Access Compliance Report

Public Rights-of-Way

(Curb Ramps)

Intersection ID: 3150	Main Street: OLD_TIMBER_RD	Cross Street: PROSPERITY_CHURCH_RD	Location: SW
ADA ID: 9E827CE84380	Ramp Type: Para	Initial Pass/Fail: Fail	Overall Compliance: No
		Severity Score: 12.5

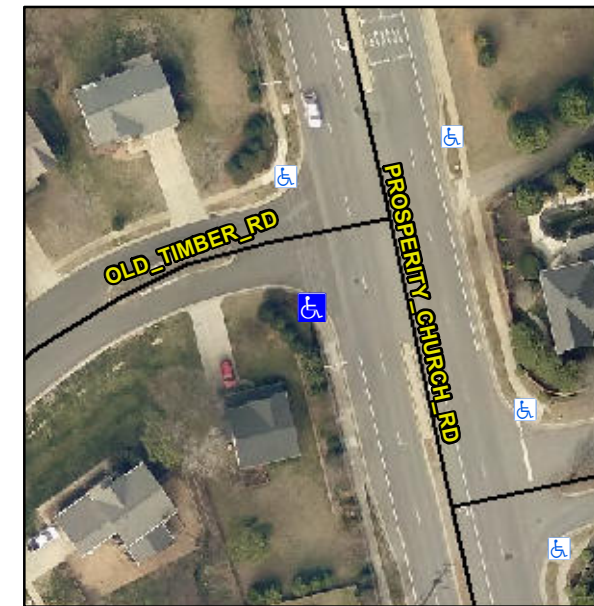
Surveyor Notes:

RT RP < 5%

PROW/ADA:

R304.3.2

Possible Solutions:

Remove & Replace Entire Ramp.
